SKT 3113C - A

Subject Alert - Adj Mandate Approved (S\$47270.16) - SKT3113C - Claim Handler: Loo, Tong Shing

Preliminary Advice

Work Order: 29407
VIN: WAUZZZF40JN15000
Technician: BENG
License: SKT 3113 C
Mileage: 6143
Date: 12.11.18 16:39

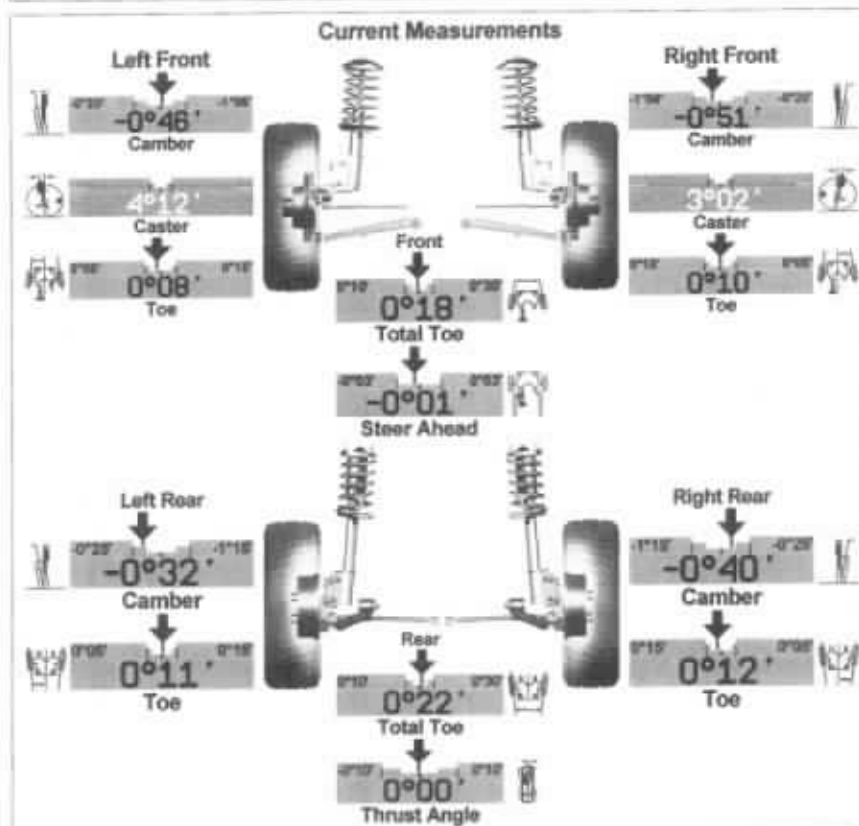
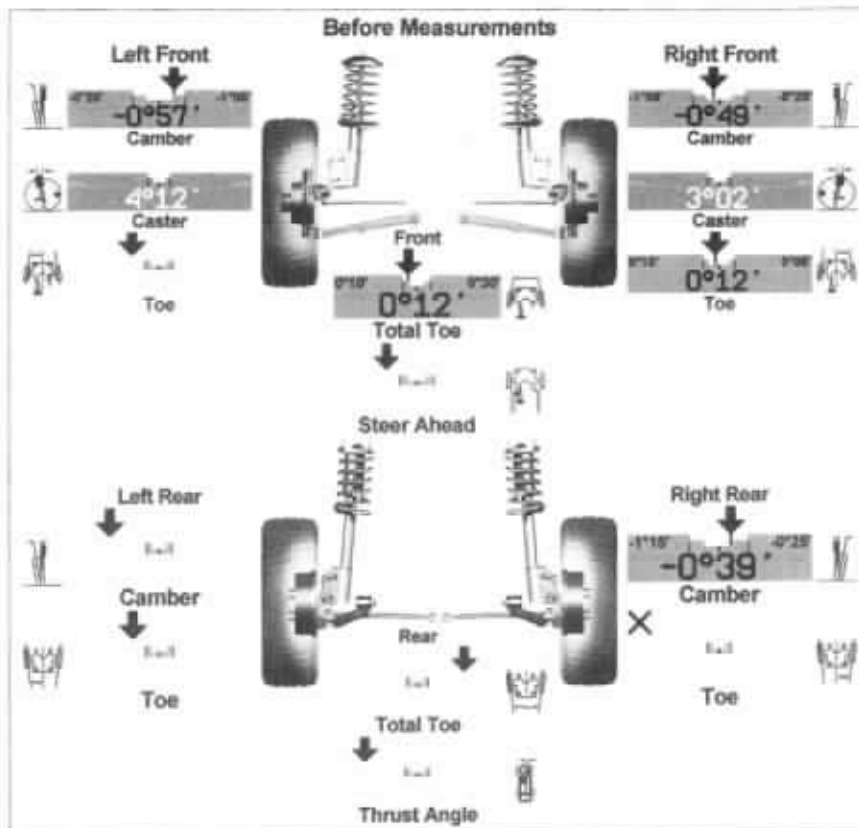
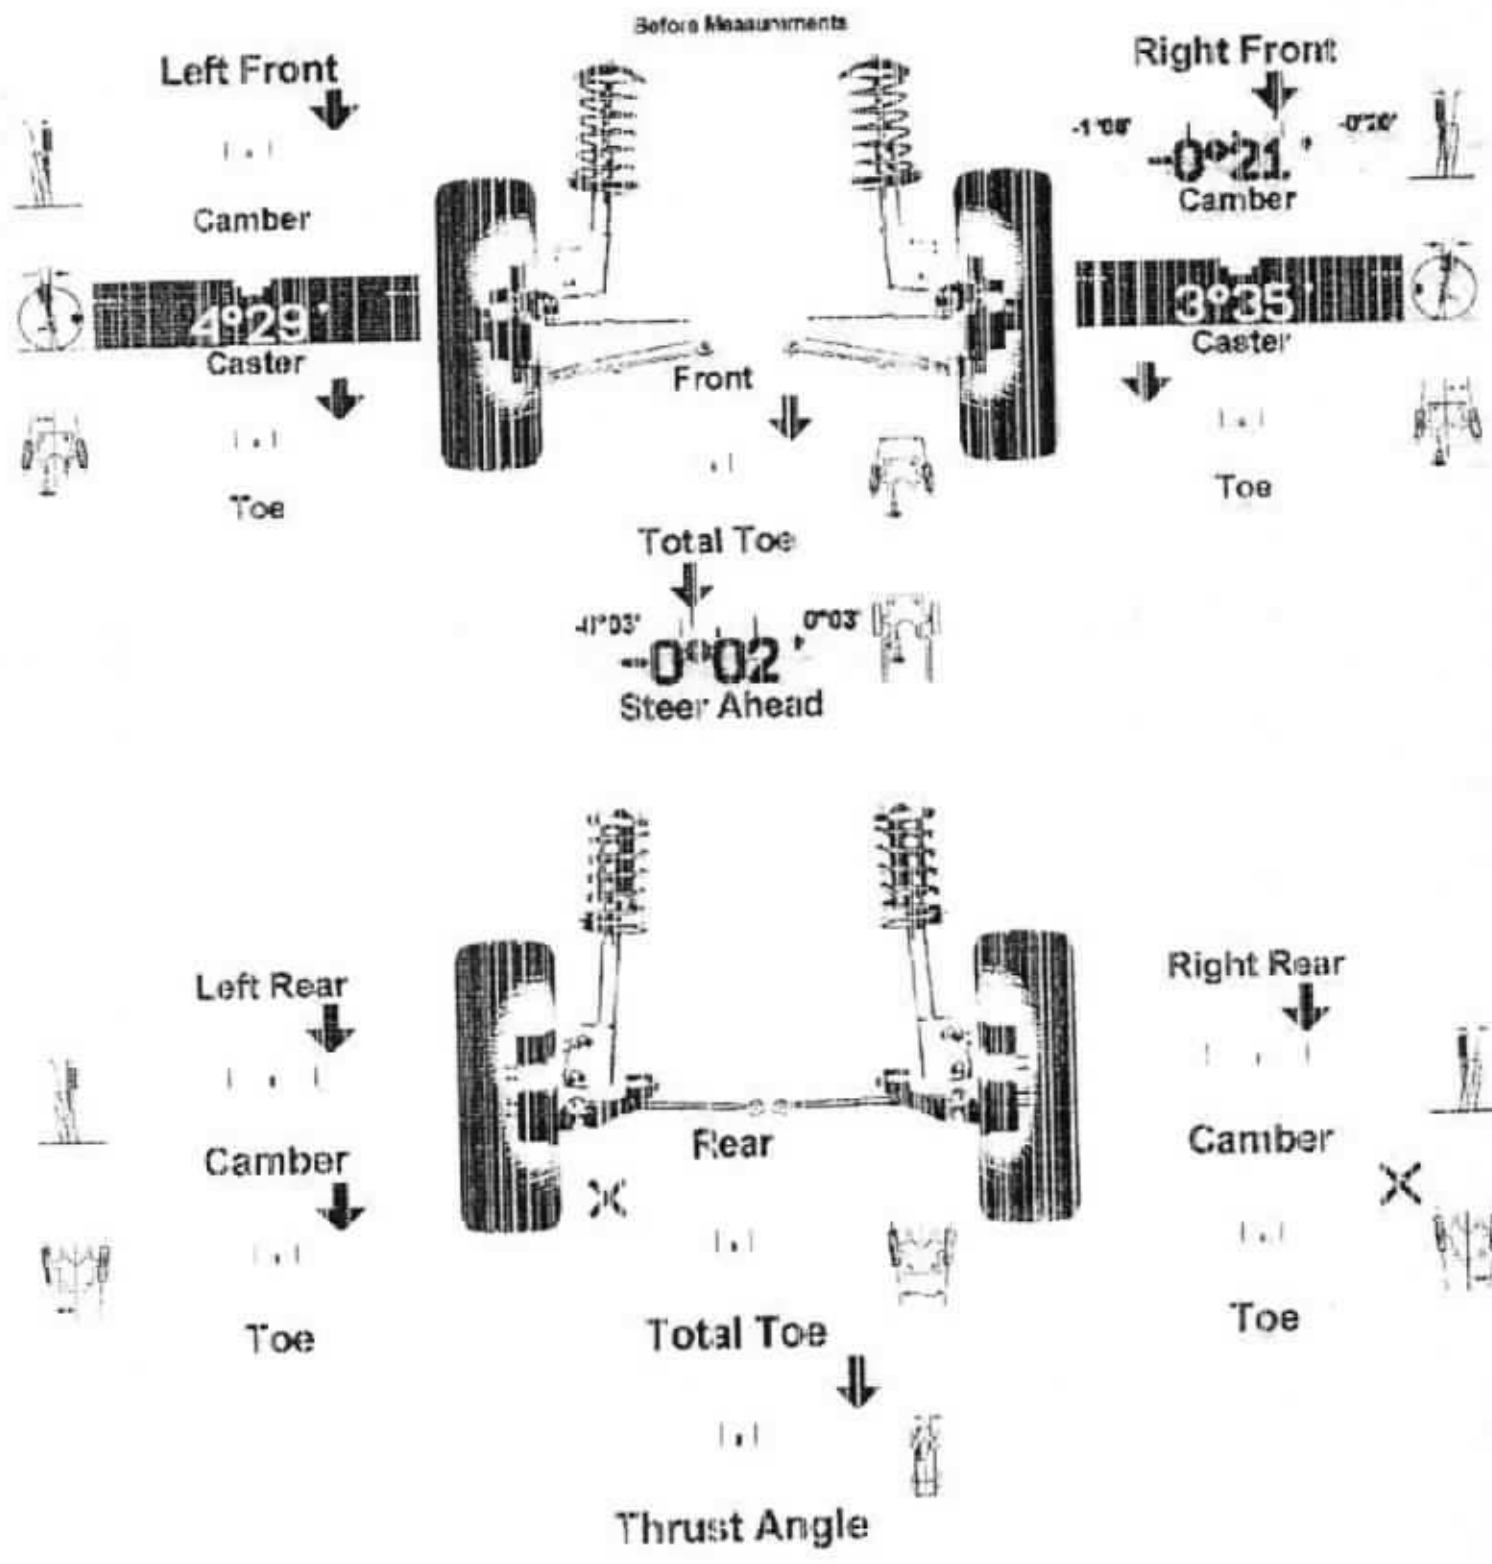
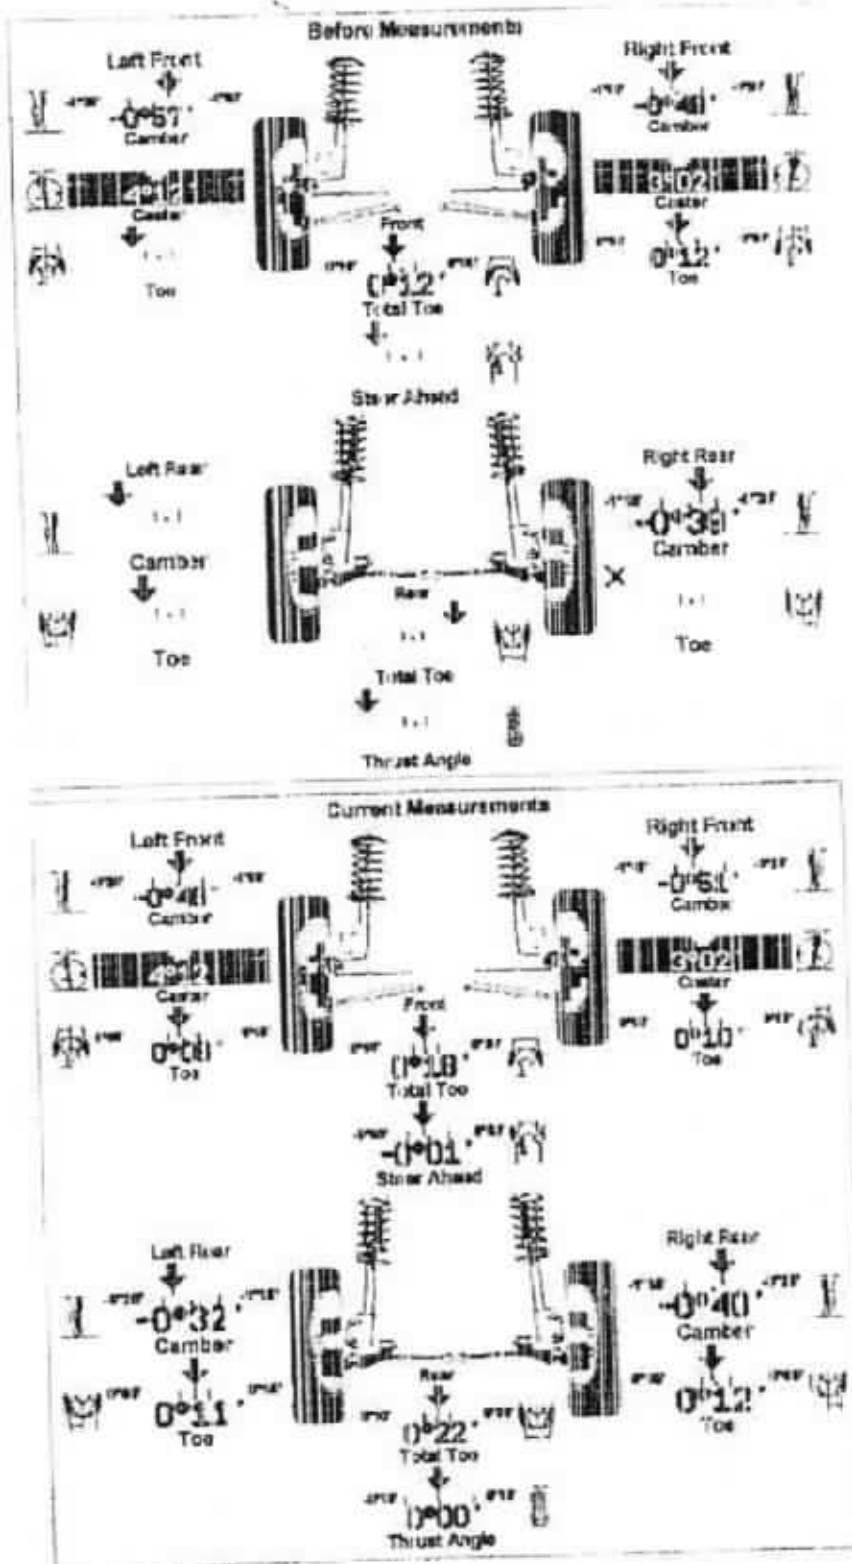
I refer to the alignment reading below. Kindly enlighten why the left side (circle in blue) which is not damage has no reading as well.

The one circle in red is after adjustment reading right and not after replacement reading. Which means the undercarriage should be ok?

Alignment report show that rear undercarriage is still within the specification?
Why does it need to be replaced?

Maintained:Supplementary undercarriage is for left or right side? If right side why left side undercarriage taken? Wheel alignment report? Parts requisition form required. Finalise marking estimate?

According to our surveyor, please note that in the alignment report, the toe angle is mark with a "X", which means that the toe angle is completely out of alignment and a reading was not registered.

According to our surveyor Adrian, please note that the supplementary list of undercarriage items are for the rear right portion.
